March 12, 2010

Constance Anderson, Environmental Scientist
State Water Resource Control Board
Division of Water Quality, Ocean Unit
P.O. Box 100
Sacramento, CA 95812-0100

Subject: Comments Concerning The Scope And Content Of The Program EIR As Stated In The Notice Of Preparation And Associated Initial Study For The Statewide Program Environmental Impact Report For A General Exception To The California Ocean Plan Waste Discharge Prohibition For Selected Dischargers Into Areas Of Special Biological Significance, Including Special Protections For Beneficial Uses

Attachment 1: Aesthetic Impacts Before and After Example

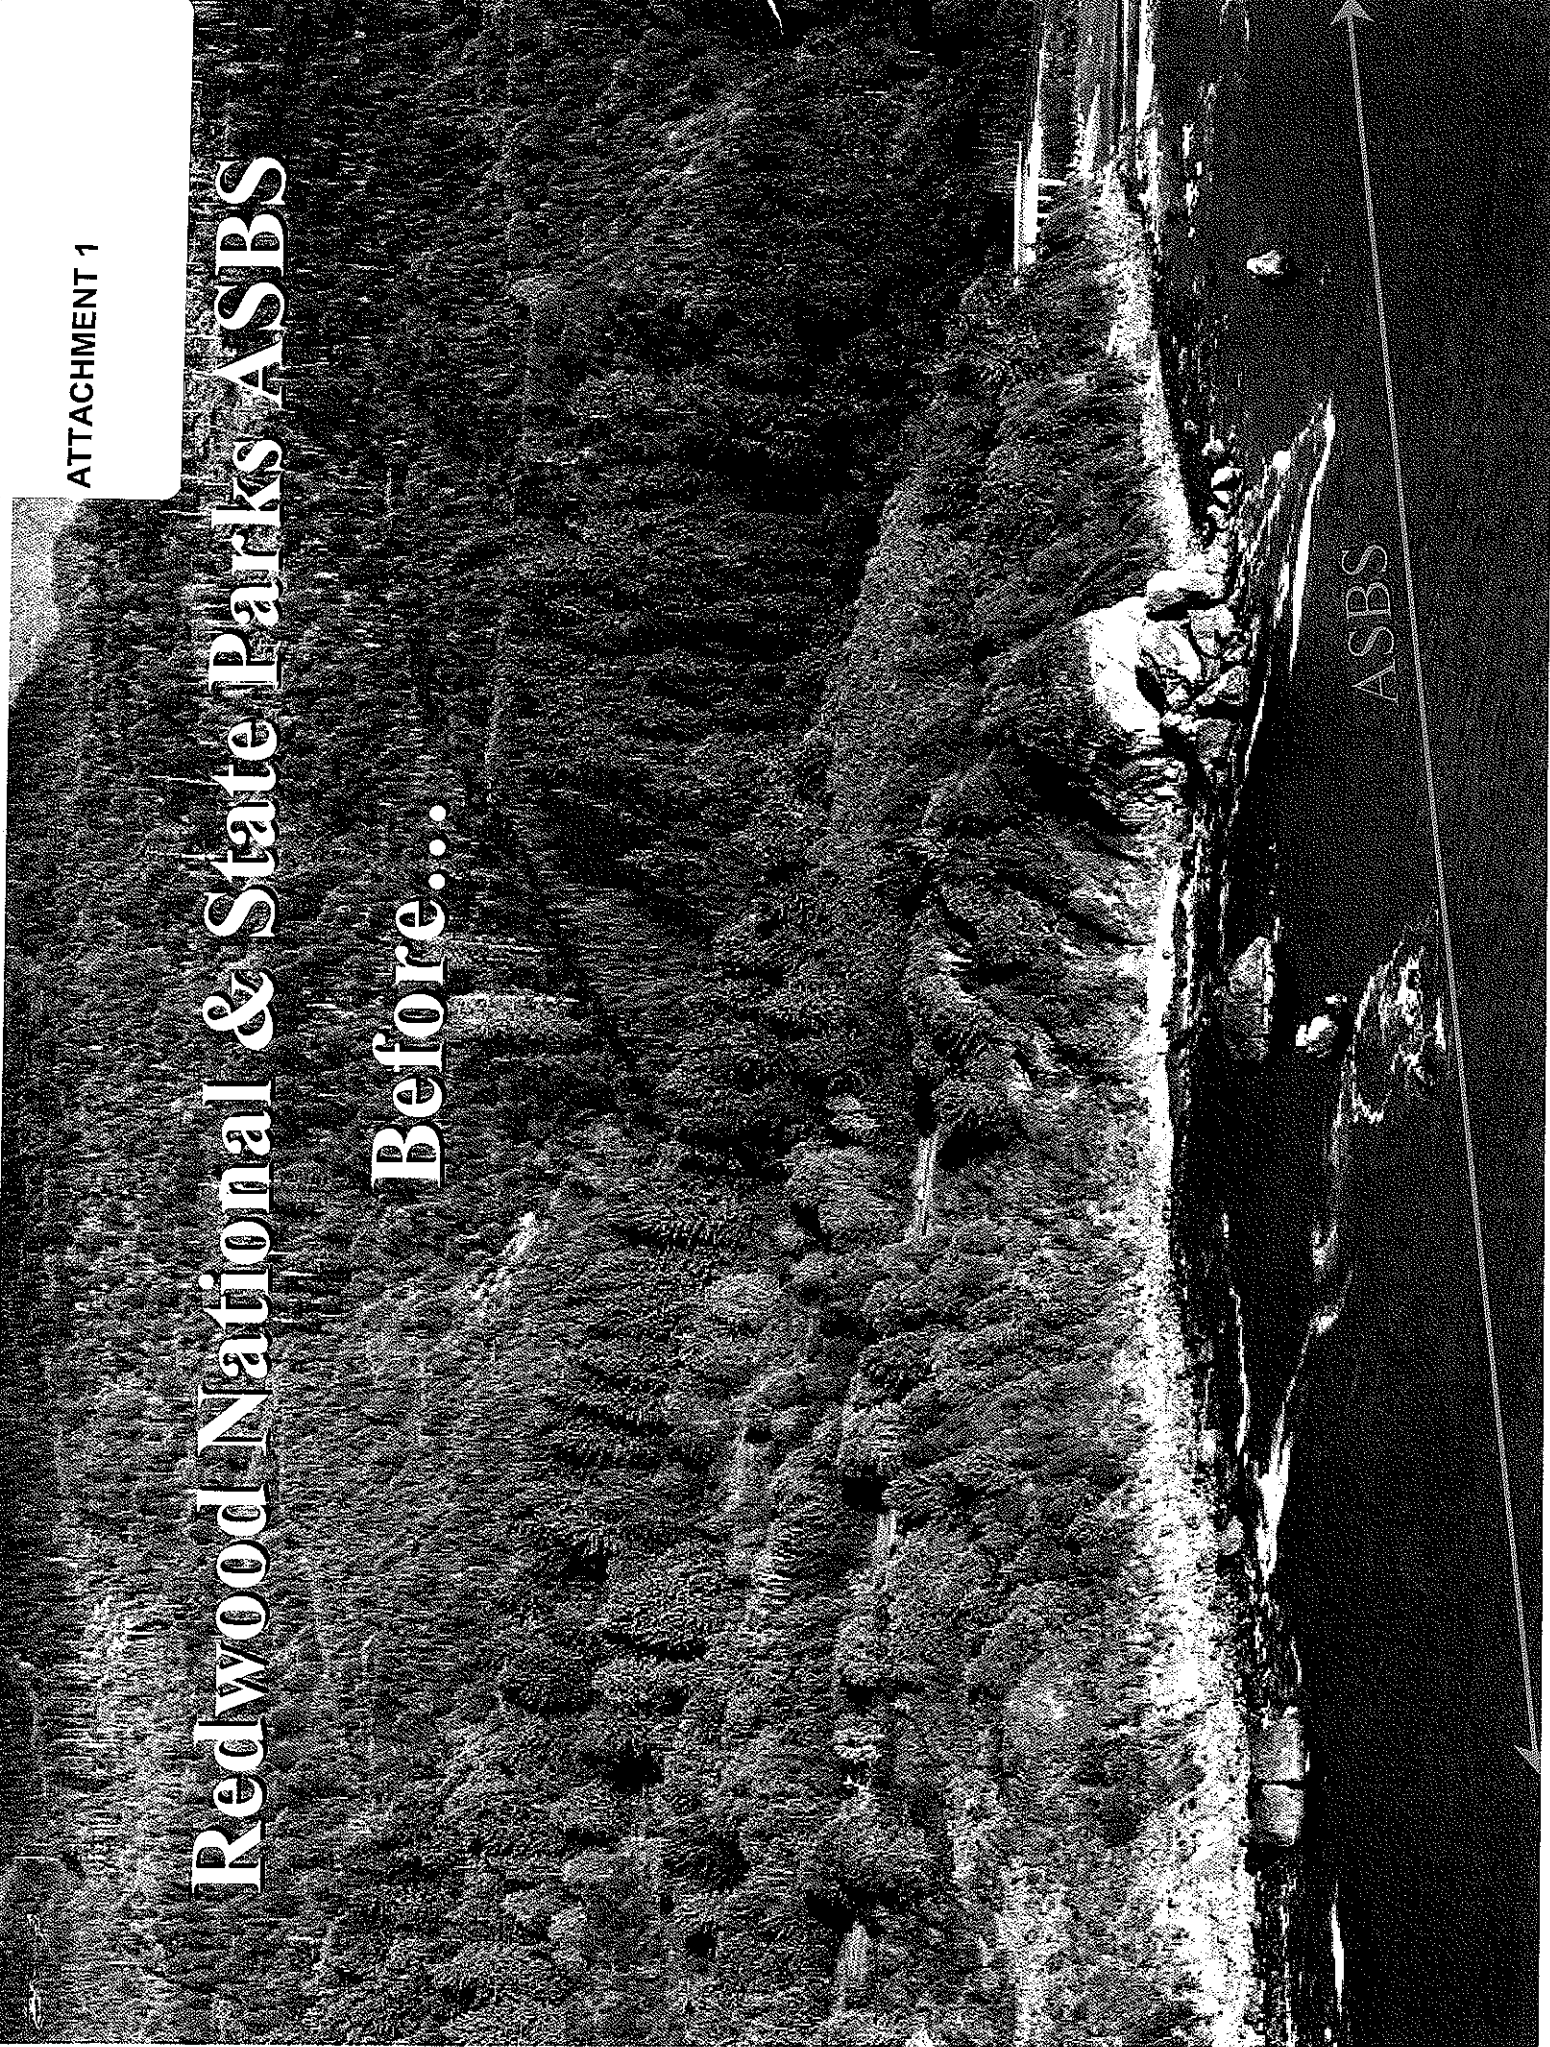
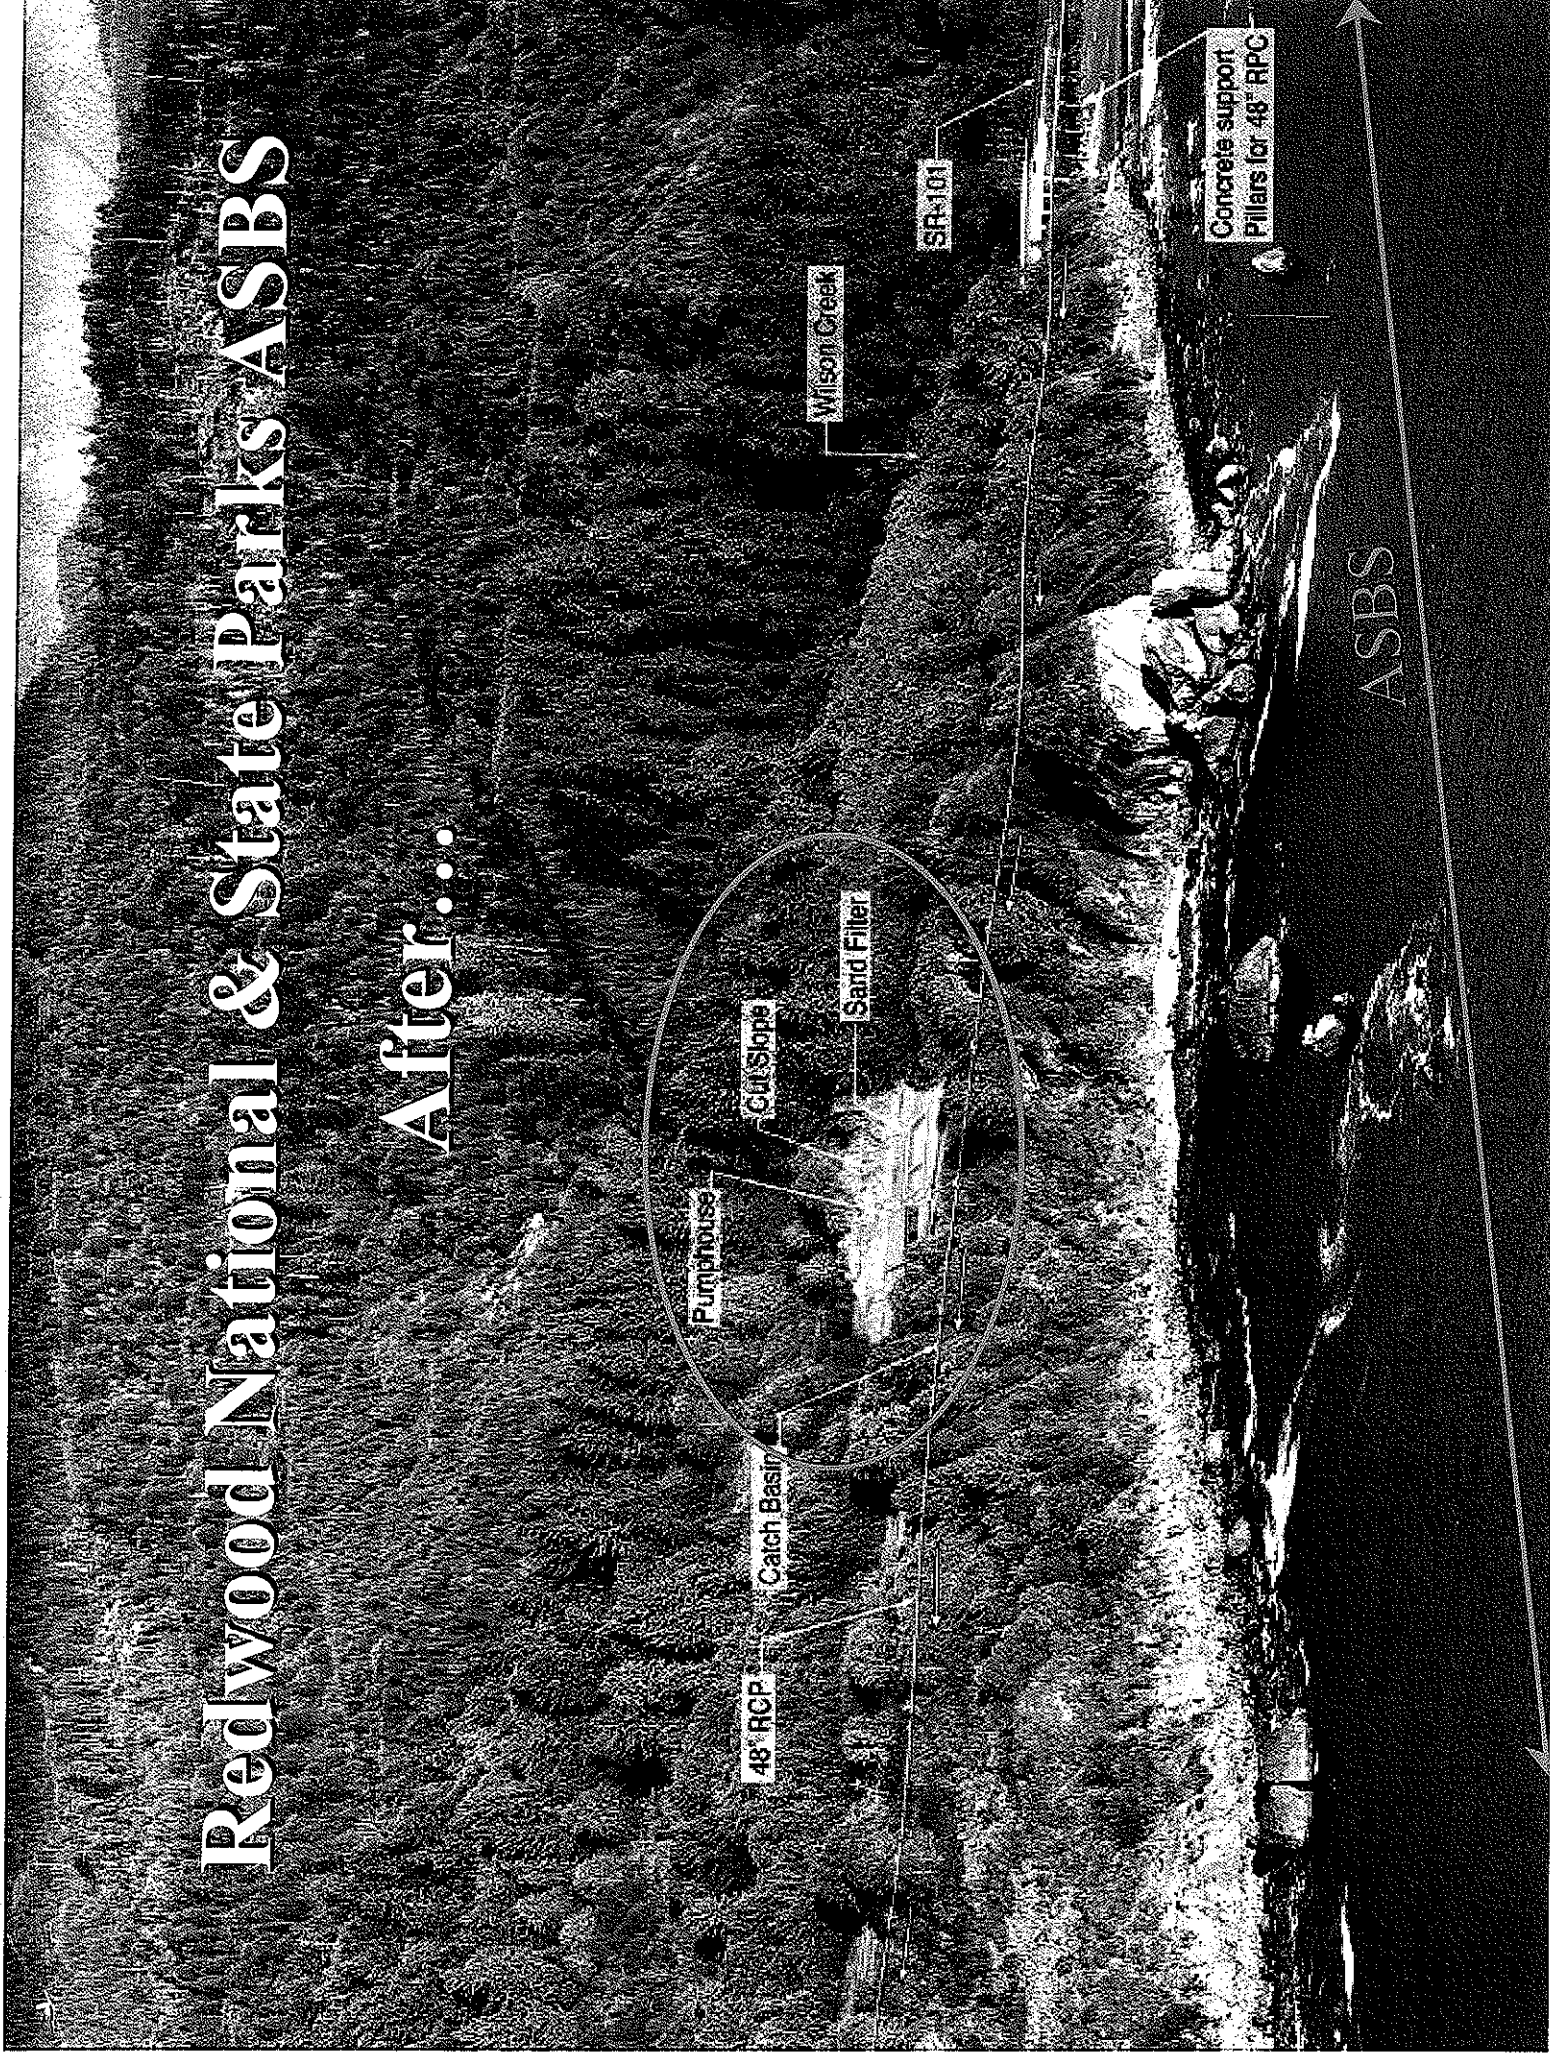
1. Aesthetics: We believe that all four components of this item should be considered potentially significant impacts. Additionally, the impacts may not be mitigated, especially in our jurisdictional area along the coastal areas of the Monterey Peninsula where end-of-pipe BMP project's may substantially adversely impact a scenic vista, damage a scenic resource, degrade existing visual character of the surroundings, or create new light or glare that may adversely affect views in the area. An example of likely impacts of a treatment system and its aesthetic impacts is shown in Attachment 1. As noted in General Comment 6 above, a brief explanation of this issue's foreseeable impacts, mitigation proposed, and supporting information sources for the conclusion, is requested.

2. Agriculture and Forest Resources: Although not pertinent to the City of Monterey, impacts may result from the implementation of this program in coastal agricultural and forest lands where a reasonably foreseeable project, such as a structural BMP or treatment infrastructure, may need to be constructed and thus, would result in

the conversion of farmland or forest land to non-agricultural and non-forest land uses. An example of impacts such as these is contained in Attachment 1. Please evaluate this potentially significant impact in part e) in this section.
